MEMORANDUM

From:	Tina Cuss Ecology Officer		
Service	WBC Ecology	App No:	252252
Address:	L'Ortolan Restaurant, Church Lane, Shinfield, Wokingham, RG2 9BY.		
Proposal:	Householder application for the proposed erection of a rooftop extension with terrace decking to the existing main building, alongside alterations to the fenestration; the erection of a rooftop infill extension to the annex building; the erection of a detached single-storey garage with dual-pitched tiled roof and facing brickwork and stone/render to match the main dwelling; landscaping and parking alterations; and the demolition of the existing single- storey rear kitchen/service extension.		
Type of Development:	Other Householder		
Site Visit Made:	No

Photographic plate showing T13 (centre). (ROAVR, 2025)

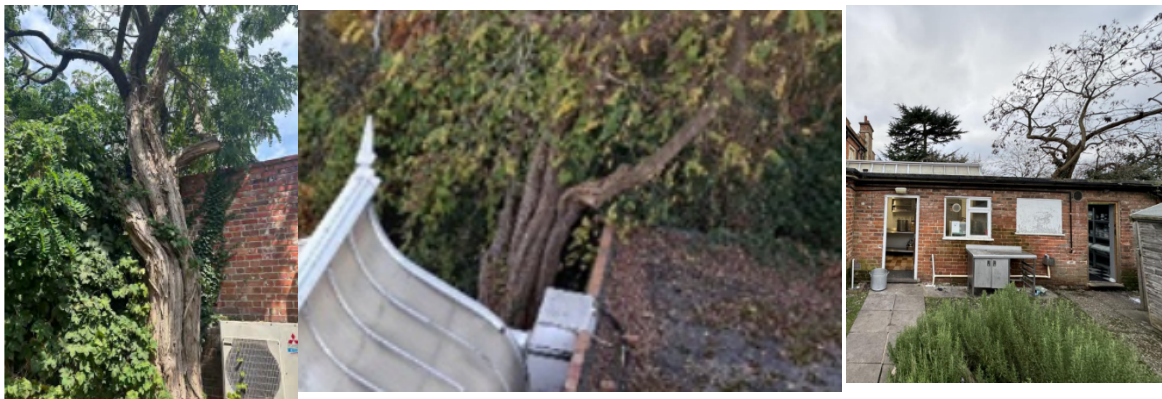
It is not clear if the Ecologist assessed the impact of the removal of T13 and whether this tree may also include features suitable for bats as no habitat plan is included in the PRA report. They fail to report that mature ivy on the tree has been severed. The Ecologist has not taken account that this tree is just 30m from the maternity bat tree roost to northwest recorded at The Manor. The AIA describes Hawthorn T13 described as having Ivy, a stem that divides below 1.5m. The Arboriculturist recommended no works to the tree and the reason for proposed removal therefore appears to be to facilitate redevelopment of the Annex which has now been removed from the current phase of development proposals.
